FIRMWARE RELEASE NOTE

2nd Generation IP Video Intercom

2nd Gen IP Video Intercom Build 190604 Release Notes

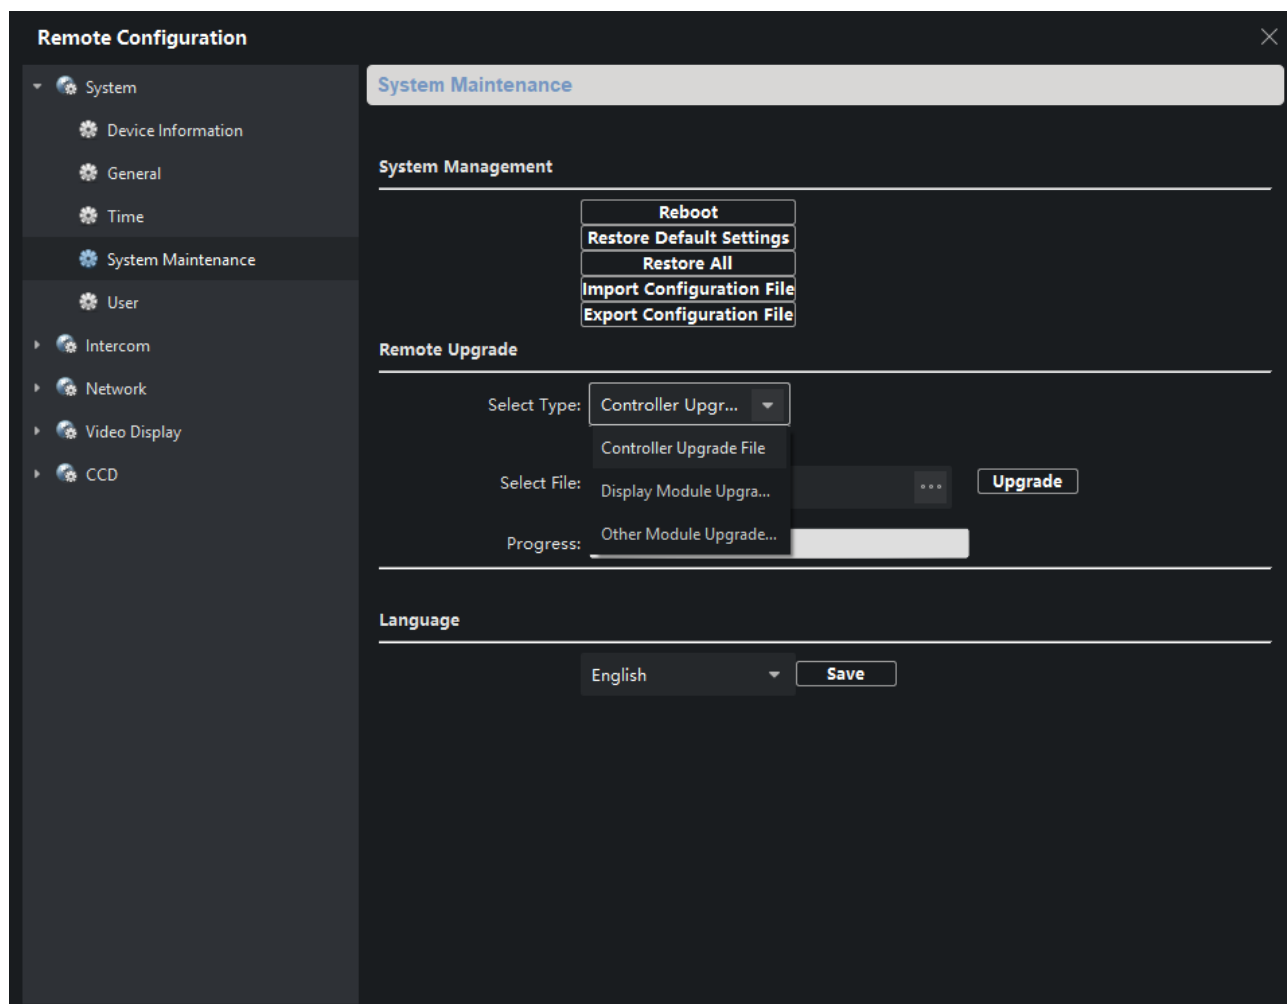
3. Supports sub modules upgrading from iVMS

All sub modules produced after May 2019 and with FW 190522 can be upgraded via iVMS V3.1.1.6 Build 190702 and later. Older modules need to be upgraded to 190522 fw via serial port upgrade to support this feature.
